2025 GROUP B PROPOSED CHANGES TO THE I-CODES

April 27 – May 6, 2025
Doubletree by Hilton
Universal Orlando - Orlando, FL

Publication Date: March 2025

FIGURE 503.1 LOCATION OF ELEVATED PV SUPPORT STRUCTURES ON OPEN PARKING STRUCTURES

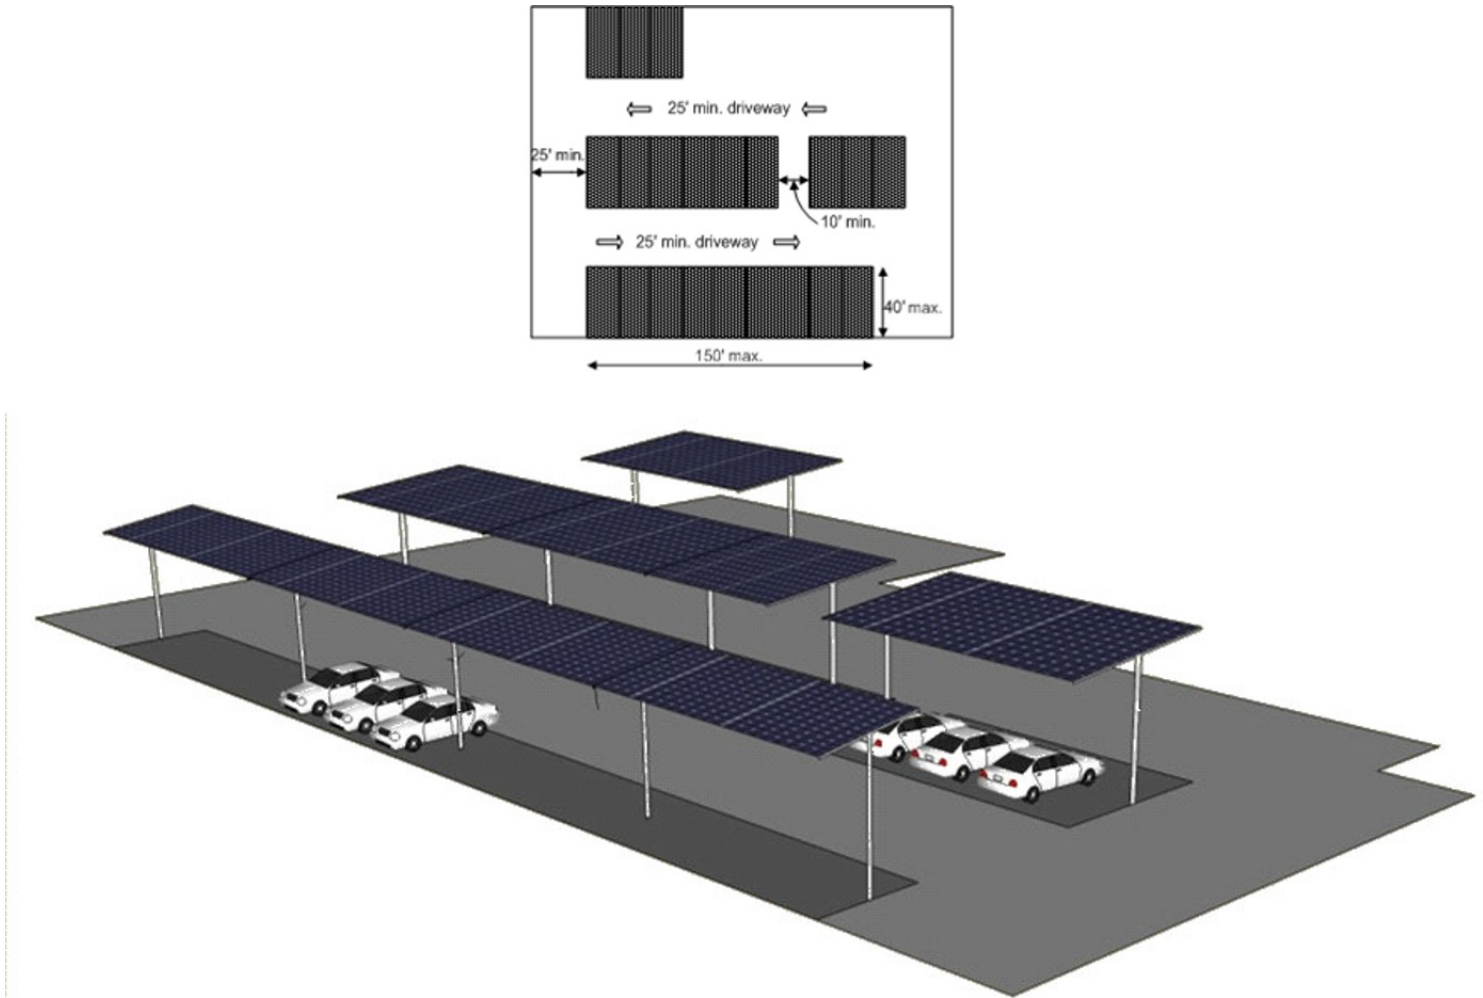
- 1.2.1. 10 feet (3050 mm) above the allowable building height.
 - 1.2.2. 10 feet (3050 mm) above the roof of the building immediately below.
2. Other than structural requirements, *elevated photovoltaic (PV) support structures* installed on the roof of an open parking structure or the roof of an enclosed parking garage shall not constitute an additional story or additional floor area and shall be permitted to exceed the height limit of a building where all the following conditions are met (see Figure 503.1):

FIGURE 3004.2.3 ESCALATOR GUARD

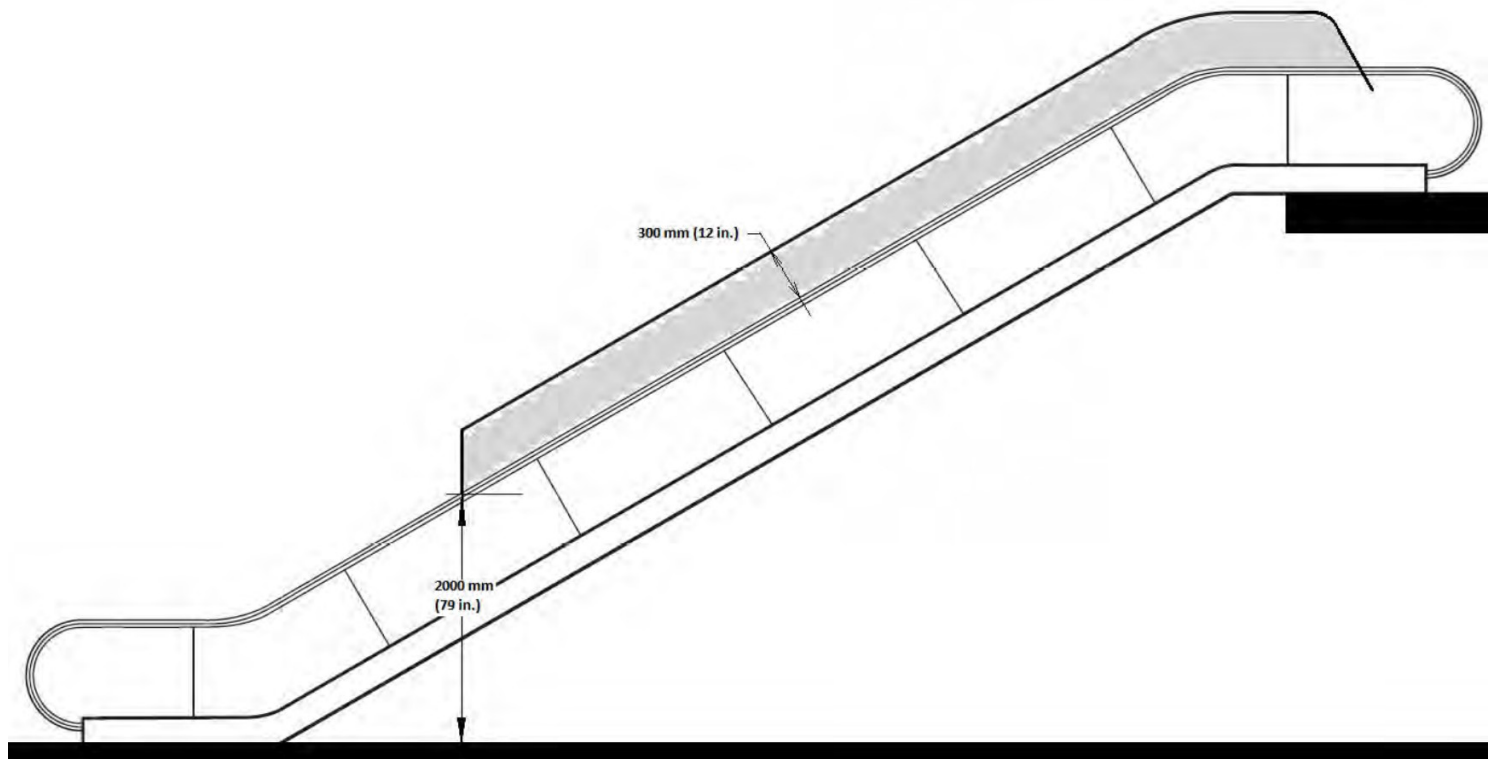
3004.2.3 Balustrades required. Where escalators or moving walks are installed with one or both sides open and the escalator step or moving walk treadway is more than 30 inches above the adjacent floor, the balustrades shall be not less than 42 inches (1067 mm) in height or the side or sides shall be guarded to comply with ASME 17.1/CSA B44, Appendix ZZ. See Figure 3004.2.3.

Figure 1609.8 Wind-driven rain wind speed (mph, 3 sec gust)
[For SI: 1 mph = 0.447 m/s]

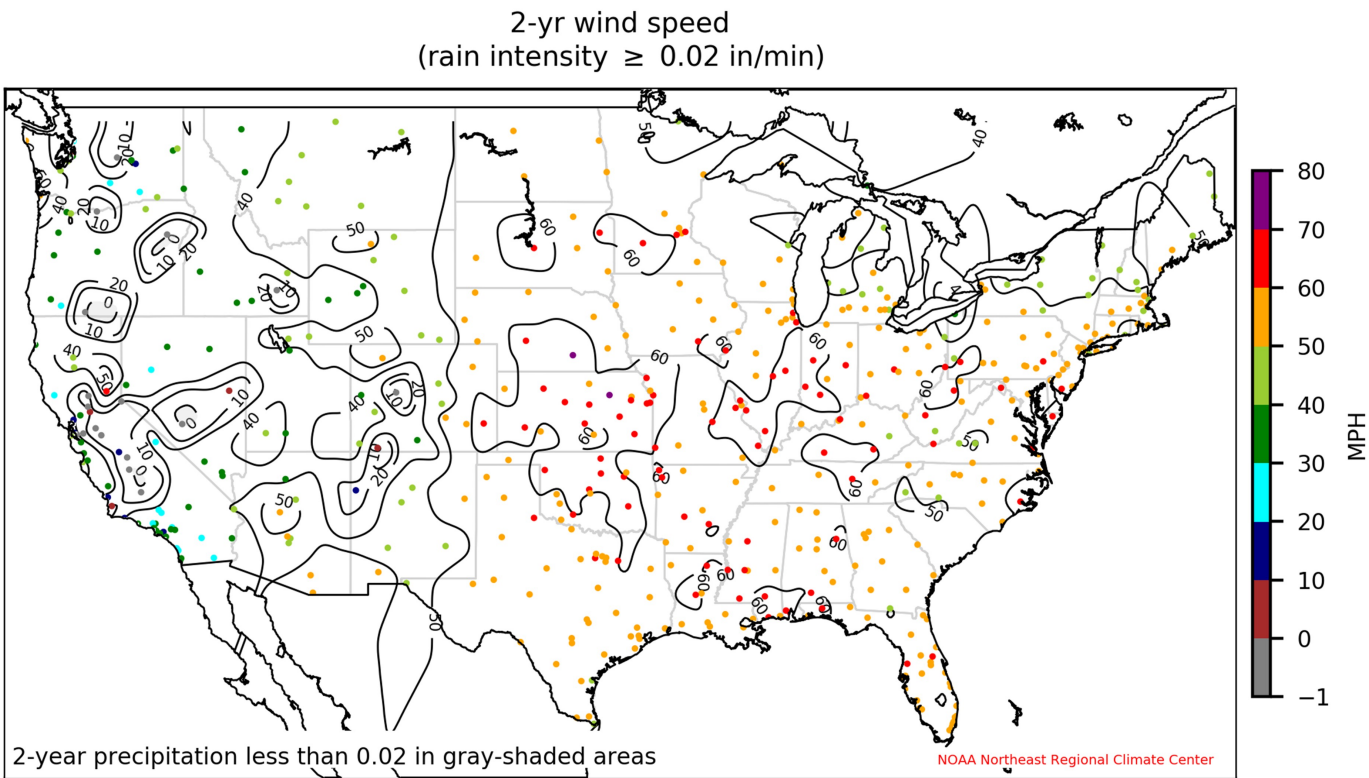
1609.8 Wind-driven rain. Minimum design wind pressures used to evaluate the wind-driven rain resistance of building assemblies and components shall be permitted to be determined in accordance with Figure 1609.8 and Table 1609.8.

FIGURE 2303.4.1.2 (1) TRUSS MEMBER LATERAL RESTRAINT AND TRUSS DIAGONAL BRACING

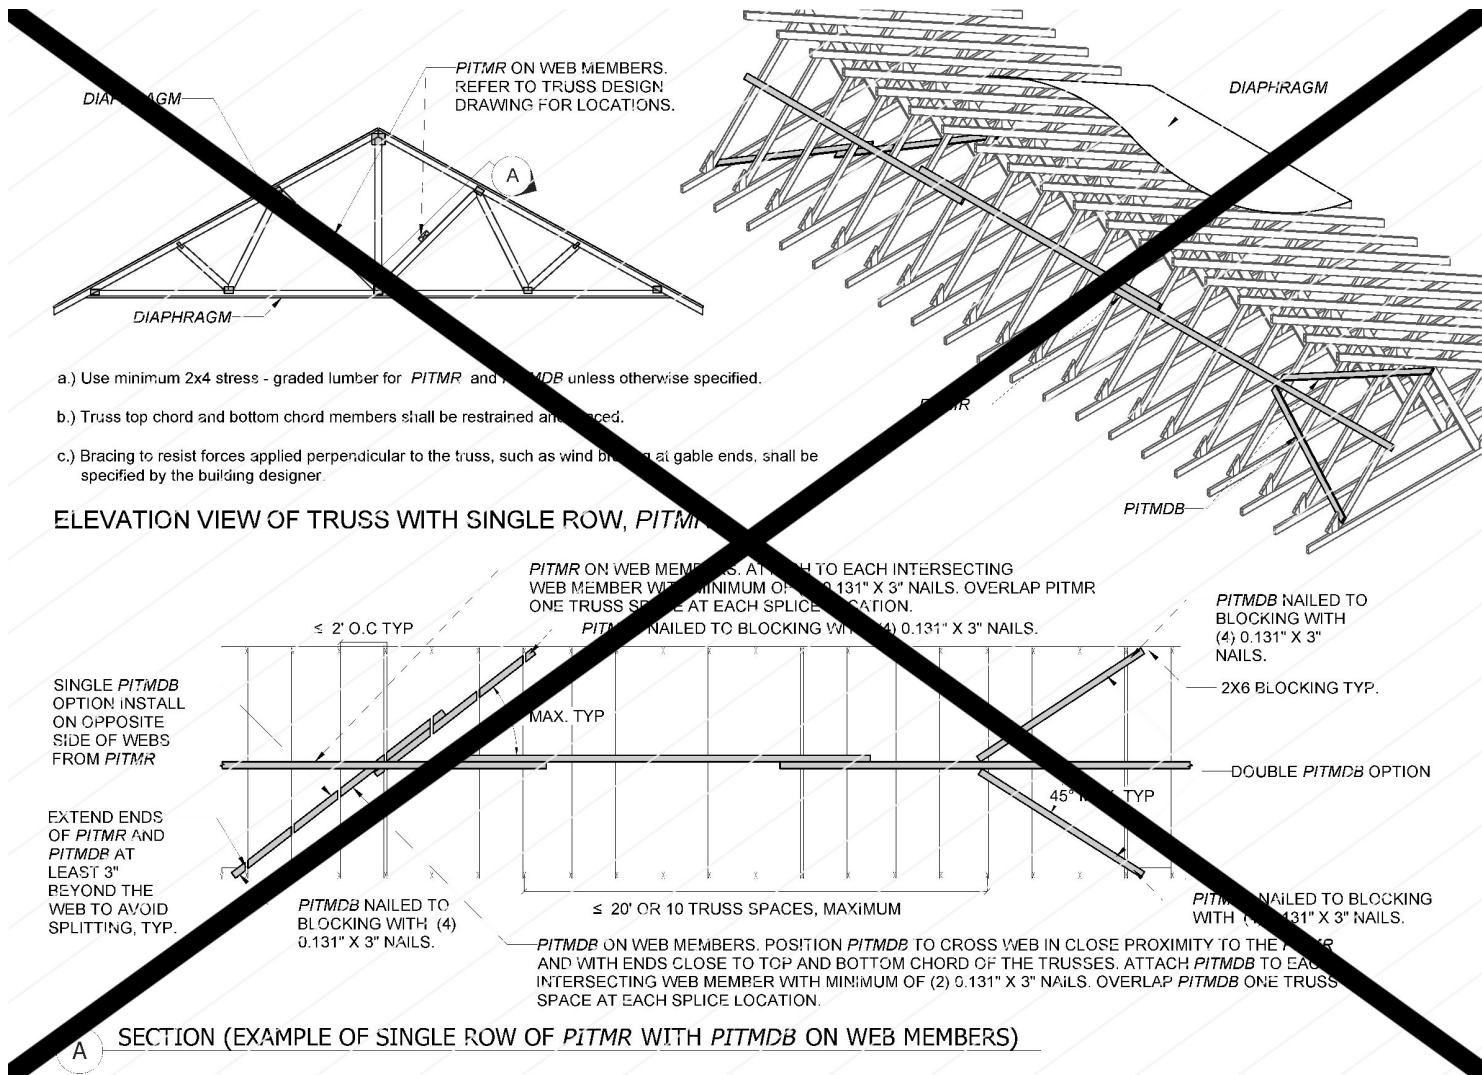
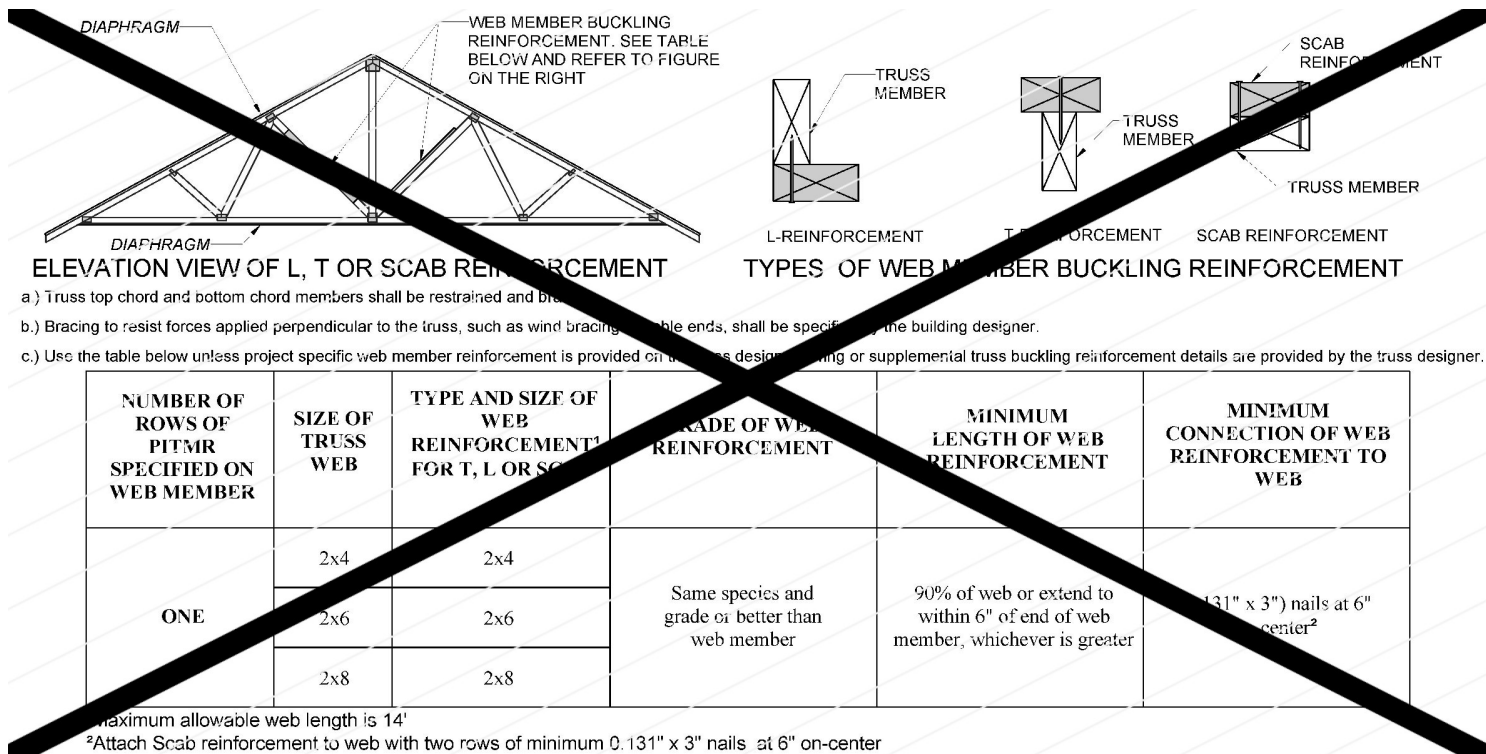
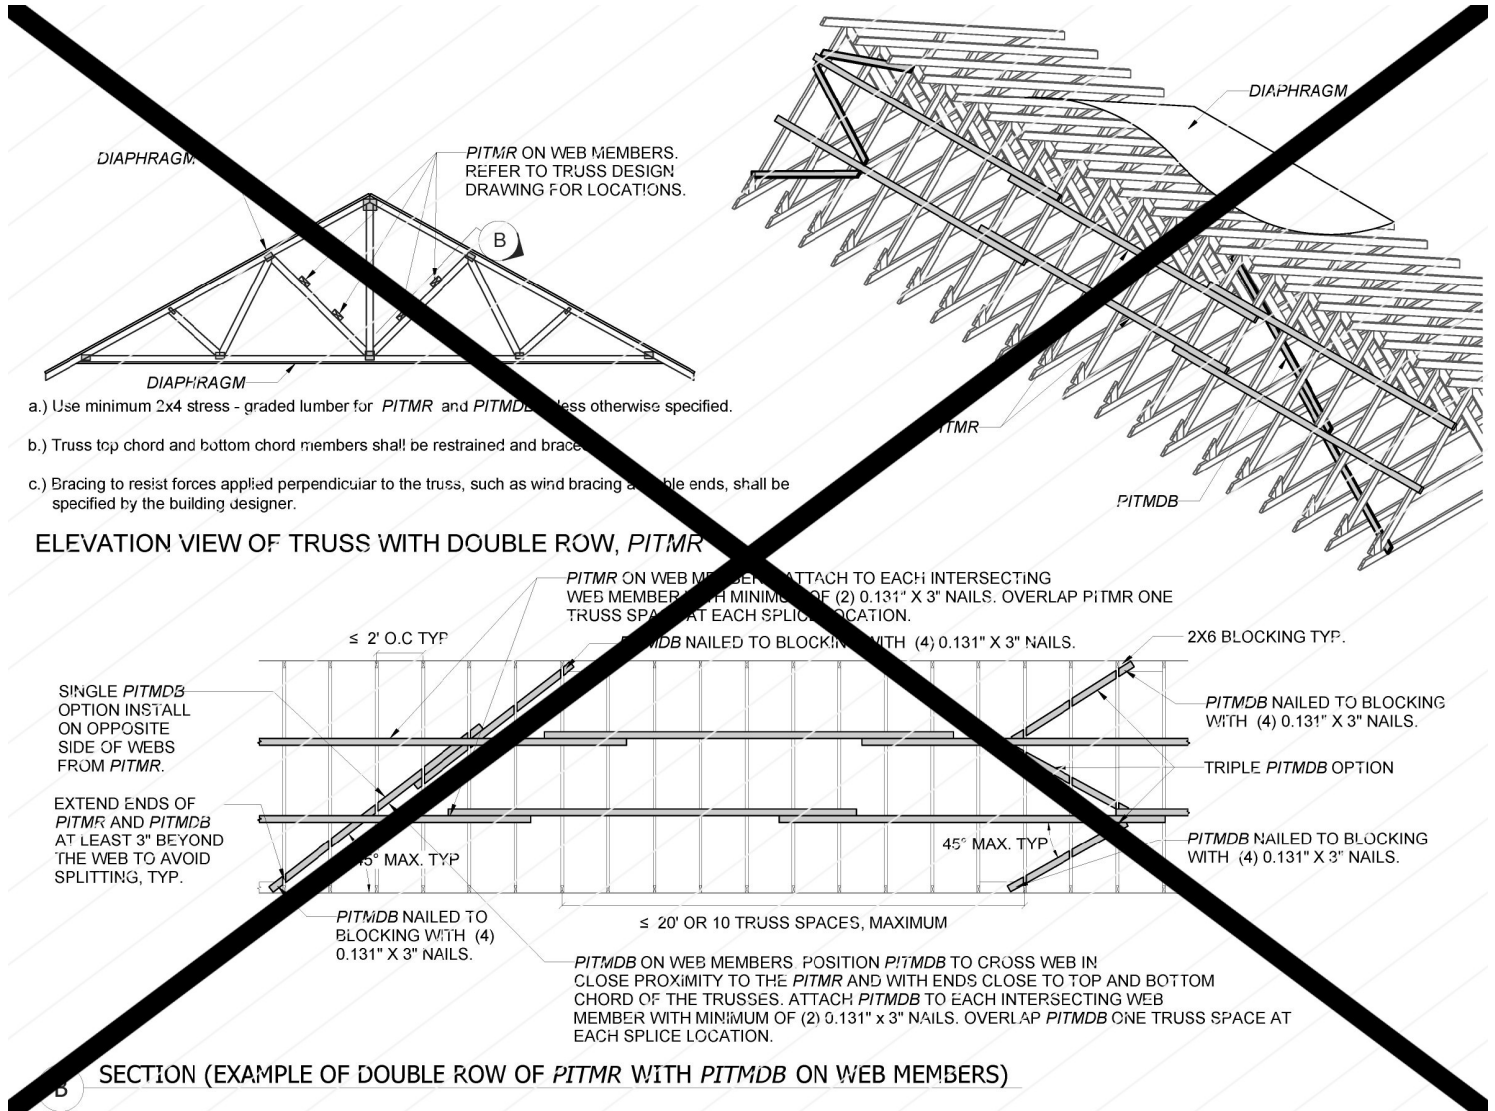
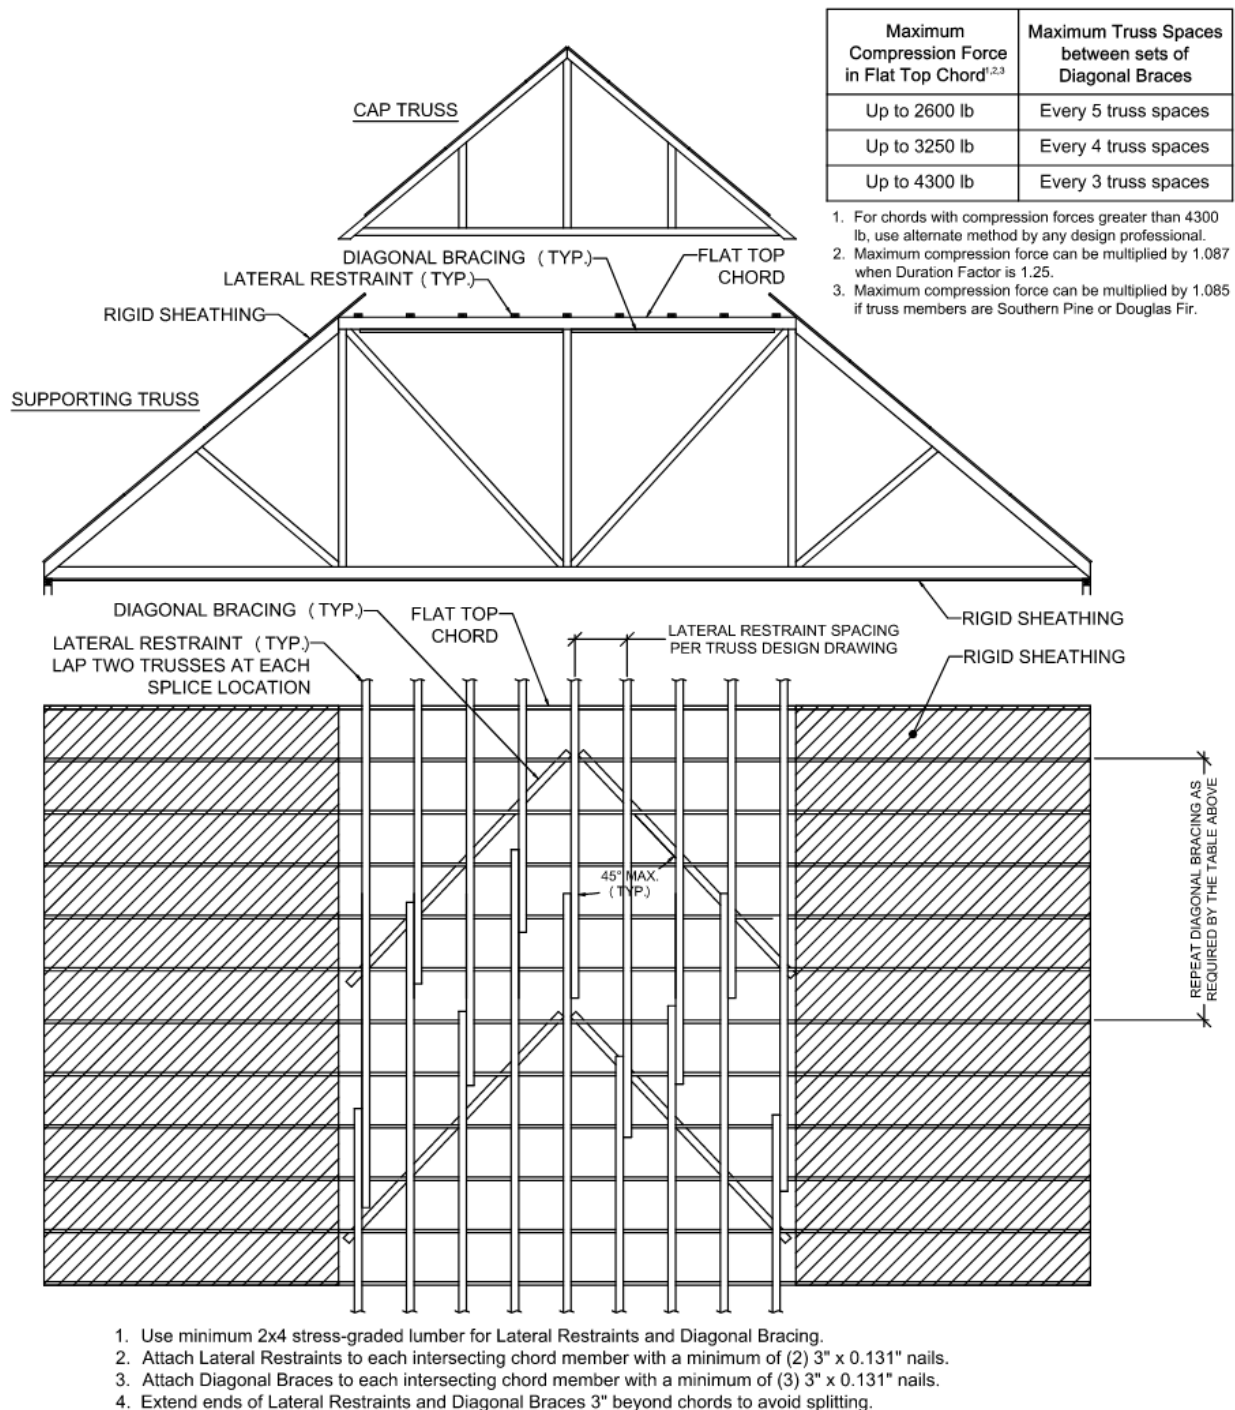
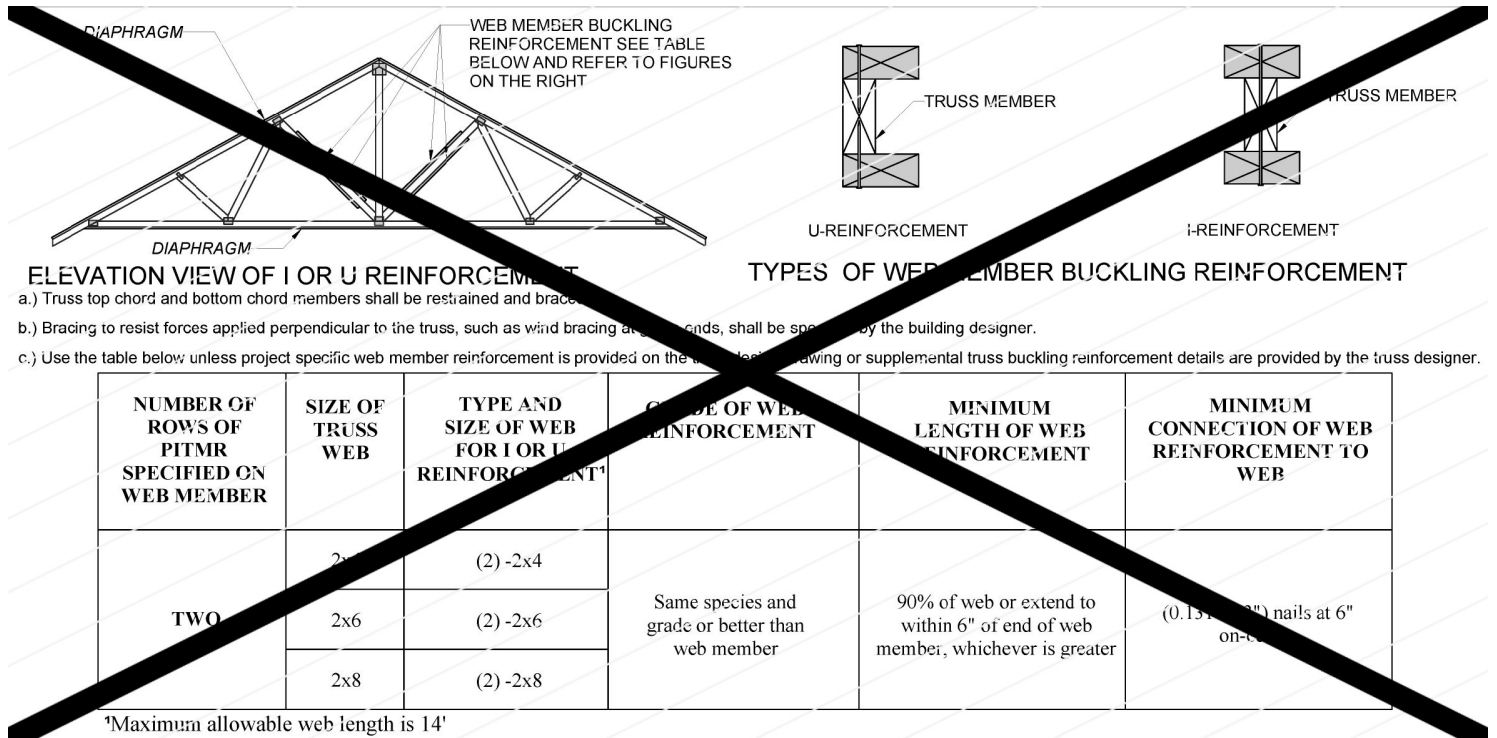
[BS] ~~PERMANENT INDIVIDUAL TRUSS MEMBER DIAGONAL BRACING (PITMDB)~~. Structural member or assembly intended to permanently stabilize the ~~PITMRs~~ *truss member lateral restraint*.
